INITIAL FIRE SAFETY ASSESSMENT

Factory Name: **MHC Apparels (Pvt.) Ltd.**
Address: **Holding-297/1, Block-B Ward# 4, Vangnahati, Sreepur
Gazipur Dhaka Bangladesh**
Assessor: **Uttaron Technologies**
Date: **19 Aug 2018**

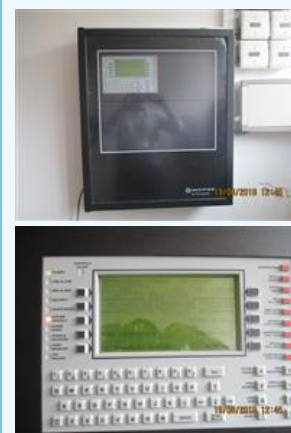
Question:	Trouble or alarm notifications were not indicated on the fire alarm control panel.	
Priority Level:	High	
Non-Compliance Level:	3	
Description:	Trouble alarm notifications were indicated on the fire alarm control panel at normal condition. The system has been found faulty and numbers of trouble alarms indicated without any valid reasons.	
Source of Findings:	Visual Assessment: The automatic fire alarm system installation is going on	
Suggested Plan of Action:	Install an automatic fire alarm and detection system for the facility and its need to be free from faulty alarm/trouble alarms. The system shall comply with the Alliance Standard and NFPA 72. Consult a qualified fire protection engineer and/or authorized fire alarm company to design and install the system.	
Suggested Deadline Date:	16 Sep 2018	
Standard:	Alliance Standard Part 13 Section 13.10 Maintenance of Fire Protection Equipment

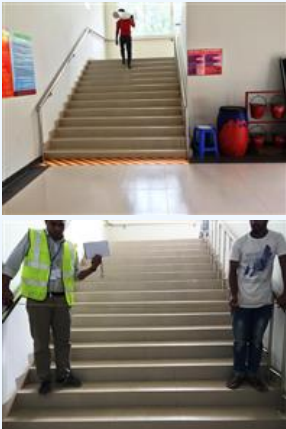
Question:	Are inspection, maintenance, and testing procedures of the standpipe and hose system documented and up to date? Including inspection and testing of hoses if provided.	
Priority Level:	Low	
Non-Compliance Level:	1	
Description:	No document regarding inspection, maintenance and testing procedure of standpipe and hose system was found among the documents have shown by the factory personnel.

Source of Findings:	Visual Assessment: Inspection, Maintenance and testing documents are not seen on site for standpipe system.	
Suggested Plan of Action:	Establish an inspection, maintenance, and testing program for the standpipe and hose system. The program must comply with the requirements of NFPA 25.	
Suggested Deadline Date:	16 Sep 2018	
Standard:	Reference NFPA 25 Chapter 6 Standpipe and Hose Systems Table 6.1.1.2
